Three Mile Island Nuclear Station, Unit 1 (TMI-1)
Operating License No. DPR-50
Docket No. 50-289
Reactor Building Spray System Modifications (RBSS)

NaOH CONCENTRATION
REDUCTION ANALYSIS
FOR TMI-1

BENCHMARK FOR
THE TWO TANK DRAWDOWN MODEL
FOR TMI-1

CONTAINMENT SPRAY SYSTEM DRAWDOWN

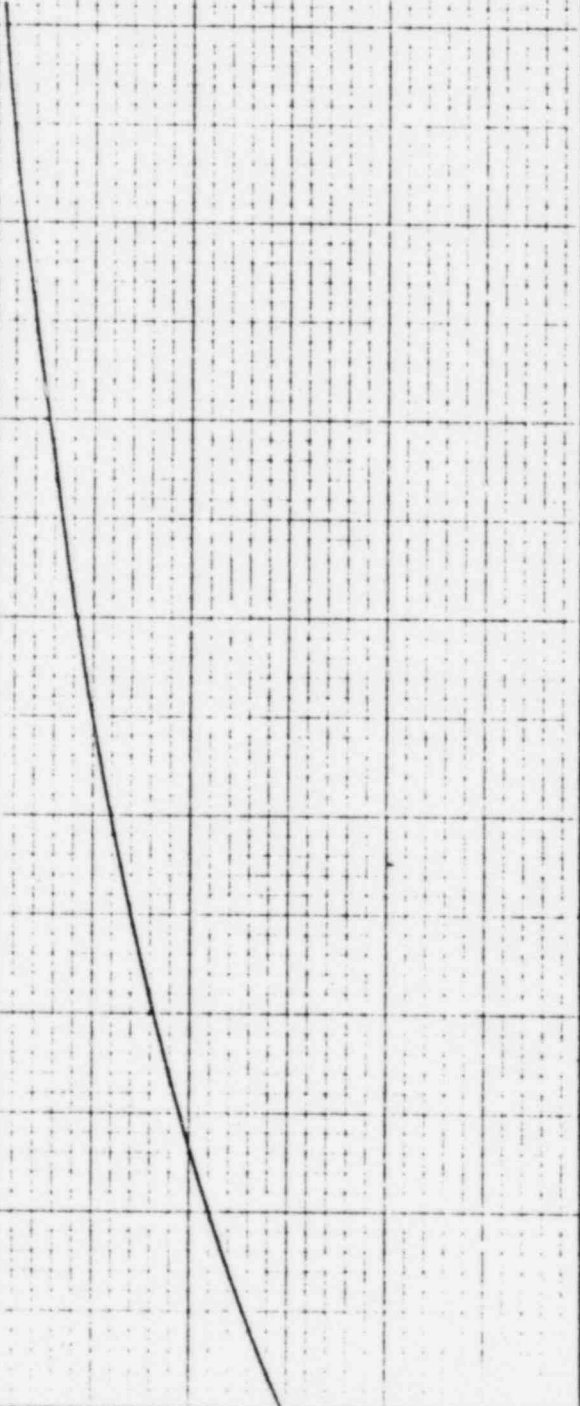
The concentration of NaOH should be minimized (and therefore, the level in the NaOH tank should be maximized) to reduce corrosion and the potential health hazard in the case of inadvertent actuation.

Results of Attachment 1 indicate that by reducing the NaOH concentration to 10 weight percent and raising the initial NaOH tank level (i.e., reducing the difference in height between the BWST and the NaOH tank from 10 feet to 8 feet) optimum system performance is achieved. Under worst case single failure LOCA conditions the pH levels in containment are reduced and the dynamic consideration of the two tank system are improved over previously supplied values. Technical Specification Change Request 107 will be submitted to include these revised tank levels.

FIGURE F-4

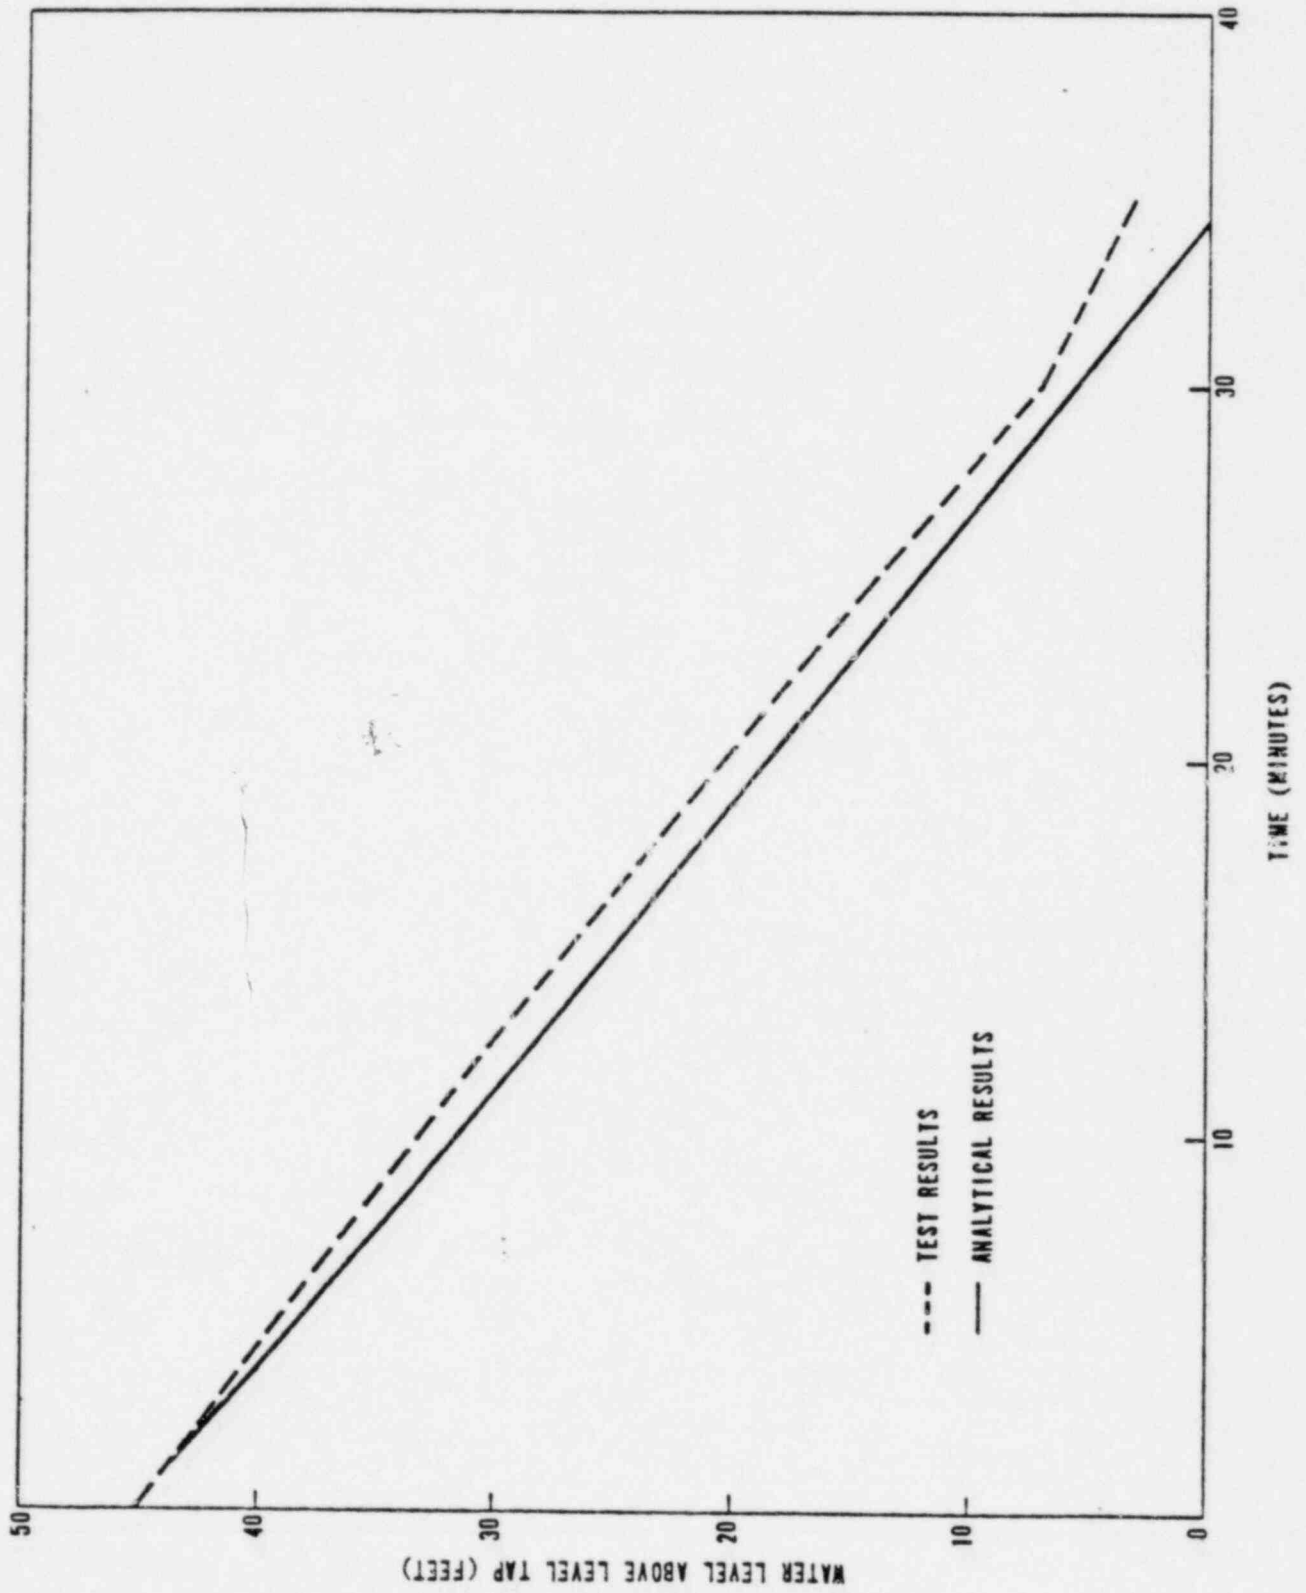
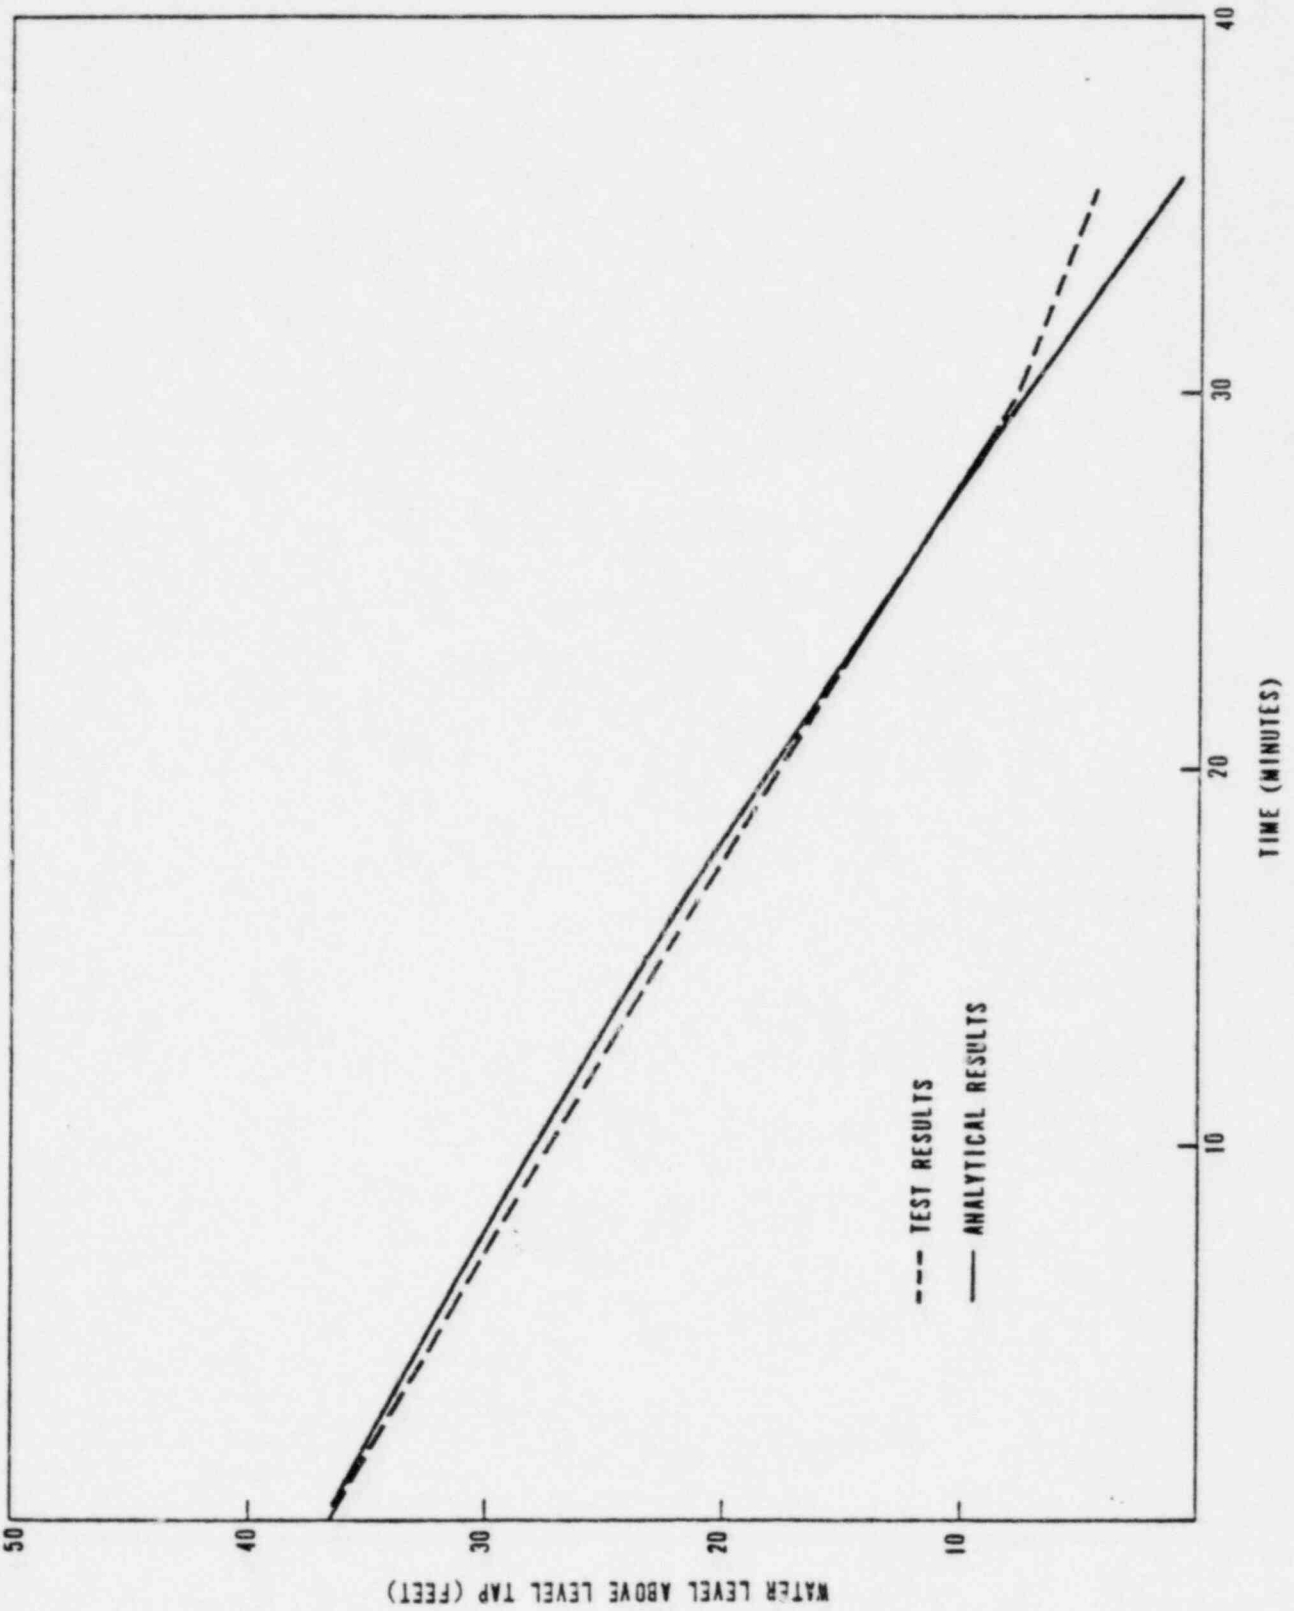
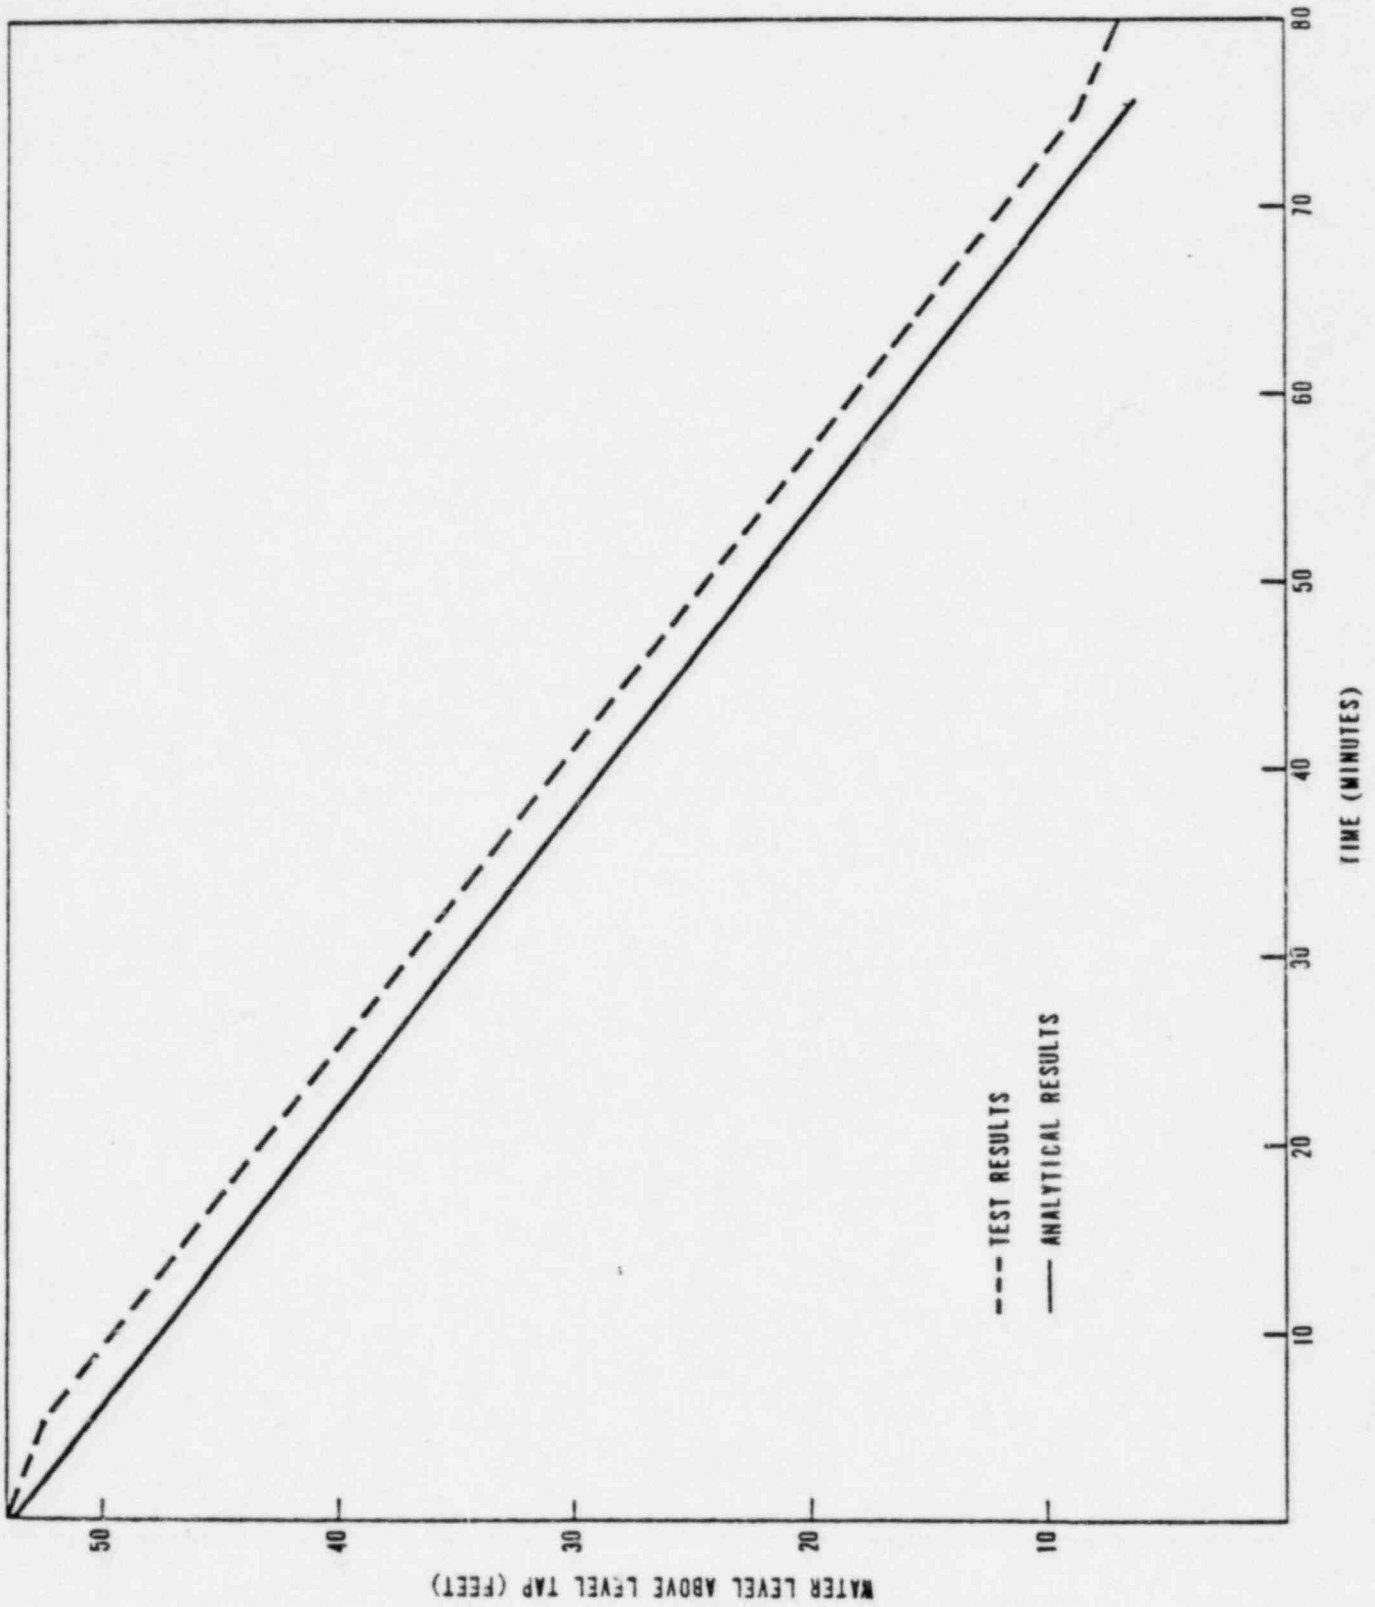
Figures F-4 and F-9 show graphically the correlation between test and analysis. The tail at that end of test data in figures F-4, F-5 and F-7 is a result of pump throttling prior to shutdown and should be disregarded. Likewise, the test data of figures F-7 and F-9 demonstrates the effect of a pump flow rate change during the test; the close correlation is still obvious.
